Staff Report

To: BOZAR
From: Jessie Earley, Town Planner III
Meeting Date: DRC, January 13, 2024
RE: (320 and 320 ½ Gothic Avenue), Secondary Review

PROJECT TITLE: Agosto 2023 Management Trust (320 and 320 ½ Gothic Avenue)

SUMMARY: Consideration of the application of **Agosto 2023 Management Trust** to site a new single-family residence and accessory dwelling to be located at 320 and 320 ½ Gothic Avenue, Parcel 2, Booth Minor Subdivision, Block 15 in the R1 zone.

1/13 DRC: revised site plan

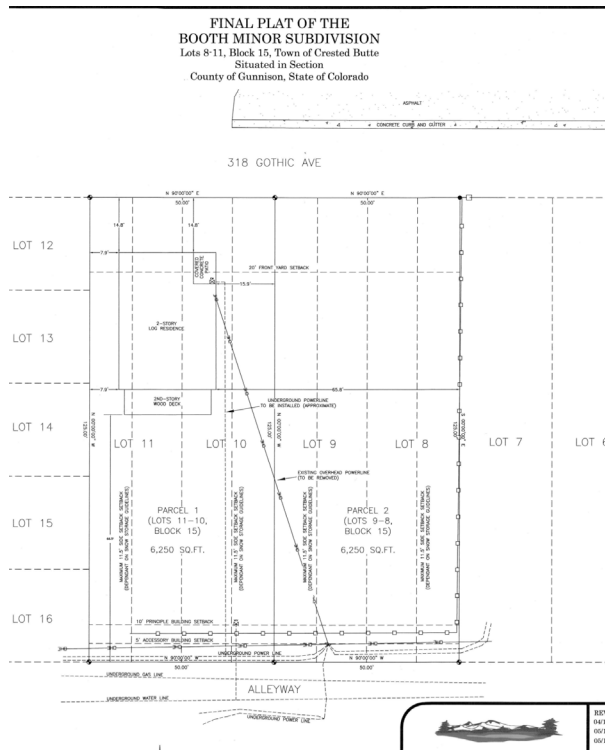
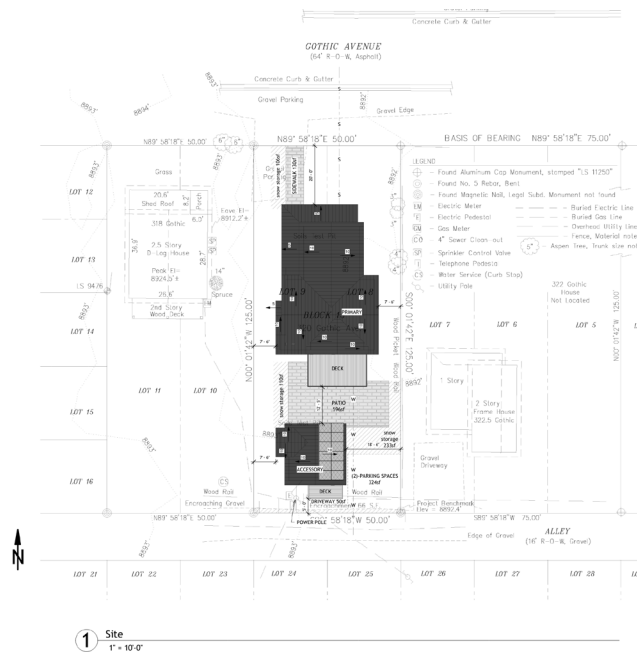
GL	Staff Analysis	DRC Recommendation
Topography	Topography has been provided. This lot slopes up from north to south from 8892' to 8893'. Grade for the purposes of measuring FAR would be 8892' for the primary building and 8893' for the ADU. Grade is not averaged for this lot. This has been updated on the elevations.

2.8 Drainage	Drainage has not been called out on the plan and must be.	
Easements	NA	NA
2.16 Substantial landscaping	The plan is fairly minimal. Provision of a final landscape plan will be required for review and approval prior after permitting prior to a CO, if changes are proposed.

2.19 New trees	There are no trees called out on the site plan. At a minimum, two trees are needed on the north.	
2.16 a./ 2.20 Native plantings	Disturbed areas have not been called out, but must be.

2.16 e Pervious materials 2.28 e & f Parking substrate	There is a walkway noted on the north side of the proposed home (130 sf). Material has not been called out but must be. There is a back entry patio below the second-floor deck on the south (596 sf) material has not been called out but must be. There is a parking area and drive on the south (371.61 sf + 58.54 sf), but the material has not been called out.

2.7 Snow Storage	Snow storage is provided onsite and meets the 33% requirement of the areas to be plowed. These areas also correspond with areas to be plowed. Support.

k. **Accessory Dwelling:** Refer to GL 2.27-8, 4.84-4.86, 4.87-4.88, 4.90.

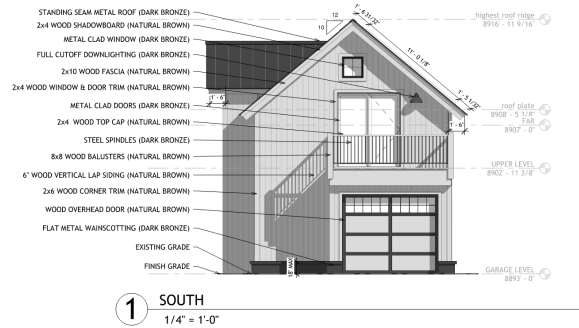
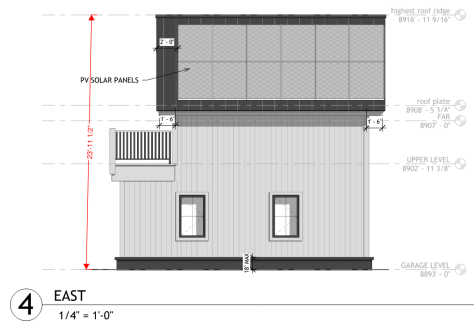
GL	Staff Analysis	DRC Recommendation
2.29/4.85/5.94 Placement	The building is set to the rear of the site. General support.	Support
2.30/ 4.84 Mass/scale/form	The building is relatively simple, as seen from the street. The forms are relational to historic styles, as encouraged by GL 2.28 and 4.84.	Support
2.30 b/4.89 Mass/scale/form	This building has a gabled ridge (10:12) running north/south with a gable pop out module (10:12) which is to the west. 3D drawings are helpful. The gable pop out module on the west helps to cover the condenser/air source heat pump on the first floor.	Support
4.89 e Fenestration	Fenestration appears fairly simple for this building. Understanding that this is an ADU, allows for additional fenestration. The solid to void ratio appears less than the main house as required by GL 4.88 b.	Support

<p>The south elevation proposes garage door and person door fenestration and a small window in the gable.</p> <p>The west proposes a large window in the gable pop out module and a single window on the second floor.</p> <p>The north proposes a single window and door glazing on the first floor and a larger window on the second floor.</p> <p>The east proposes two single windows on the first floor.</p> <p>Windows are shown as two over two, double hung style windows. Support.</p> <p>Windows are shown as casement for egress and awning with simulated divided lights. Casements must comply with 4.54 and have a divider mullion to emulate the double hung style window, which is shown. Support</p>	
Roof Forms	The 10:12 roof pitch is consistent with the existing roof pitch on the main house.	Support
Doors	<p>There is half light metal-clad person door on the rear (north) (dark bronze).</p> <p>The secondary door is shown as a full light metal clad (dark bronze) sliding door, which is not supported by 4.66.</p> <p>The garage door is proposed as a ¼ light door with a wood veneer (natural brown) and meets the intents of GL 4.90.</p>	12/9 DRC: Members had concerns regarding the sliding door, which has been revised to a French door.

4.89 d Porches	GL 4.89 d speaks to decks. This is located in the rear but will be visible from the south in the alley. Staff finds support, as proposed.	Support
